Source: CIGRE B4_113_2012: "A Survey of the Reliability of HVDC Systems Throughout the World During 2009 2010"

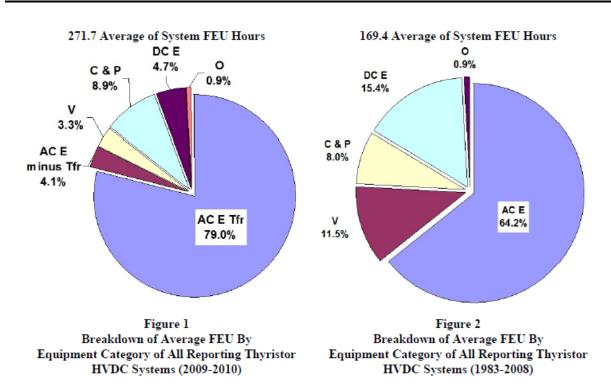
With reference to CA/SBA IR-194 and Appendix 3.01, page 76, please provide any reports, studies, reviews, or other materials with the analyses of the industry statistics related to the based on VSC technology HVDC converter valve groups and their cooling systems, including aging evaluation, forced outage rates, reliability in service, failure modes, etc. To the extent a report is subject to the strict copyright laws (e.g., a CIGRE report) please provide a summary of the report observations and conclusions.

As indicated in the response to CA/SBA IR-194, protocols have been developed for data collection on VSC installations, but the industry has not yet started compiling the statistics. The following is summary data from CIGRE for LCC installations for the operating period 2009-2010, showing the relative contributions of various components in an HVdc system to the overall Forced Energy Unavailability of the system. The components referenced in the figure are:

5 These statistics demonstrate that in both periods (1983-2008 and 2009-2010); AC Equipment and 6 Auxiliaries (AC-E) are the dominant contributors to Forced Energy Unavailability. Within the 7 category of AC Equipment and Auxiliaries, transformers have been a significant contributor. The 8 contributions for Valves (V) cannot be validated for VSC installations, but a significant 9 reduction of FEU contributions from LCC thyristor valves has been observed in recent years.
